Technical Service Bulletin

Cobra Motorcycle Mfg.

TSB0311 Kick Lever for older models

Cobra King and JR models 2010 and older use the ECDC0046 clamp style kick lever.

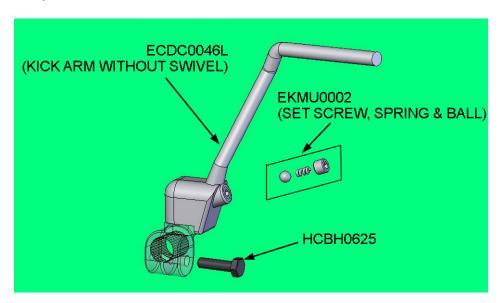
This kick lever assembly is no longer available for service replacement as the clamp style 'pivot' is now obsolete. We do still offer the following replacement parts to help service older units.

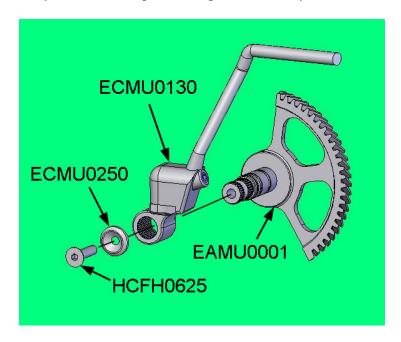
If a complete kick lever assembly is required, customers will be required to purchase a new style kick shaft/gear along with new style kick lever assembly.

If the threads strip out of the ECDC0046 swivel, a longer bolt with a nut may be an option, or likewise a heli-coil, may be a cost effective alternative to purchasing a new kick lever and gear.
